TECHNICAL BULLETIN

Doc Nr : PDX2023-01
Date: 3/07/2023
Issued by: Technical Training & Support (TTS)

Subject	<u>New gas tap</u>
Action in Factory	New model in production on XP range.
Date or s/n of introduction	WK27 2023 or Serial 3272xxxxx
Action in Field	New and Old gas taps <u>are not interchangeable</u> due to certification matters.
Spare parts	Old tap remains in production for older appliances as spare part ; new tap in production for appliances manufactured after WK27-2023 and available as spare part. Spare part catalogues are updated and loaded into the web site.

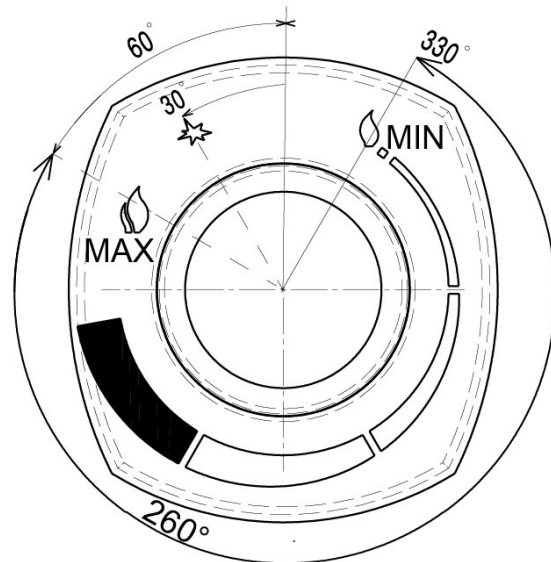
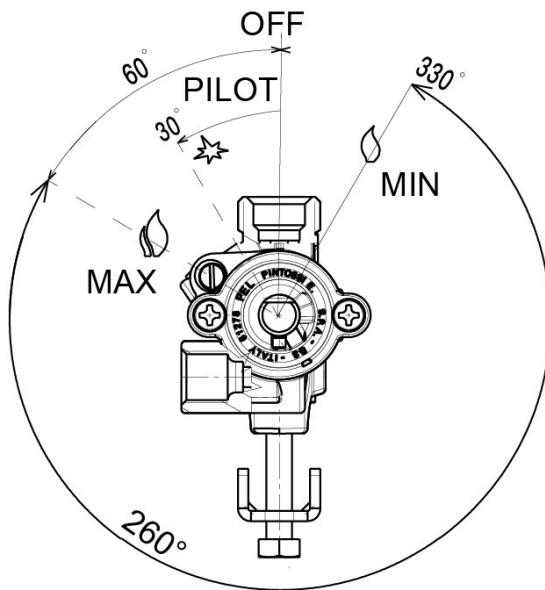
starting from Wk 27 of 2023 (July) will be introduced ,on most of **XP GAS COOKERS**, a new model of gas tap.

The new tap has a more flexible adjustment stroke (compared to the older model) , with this model it will be easier to adjust the output burner flame.

Due to certification the new and old gas taps are NOT interchangeable. The “old” gas tap remains in production as spare part.
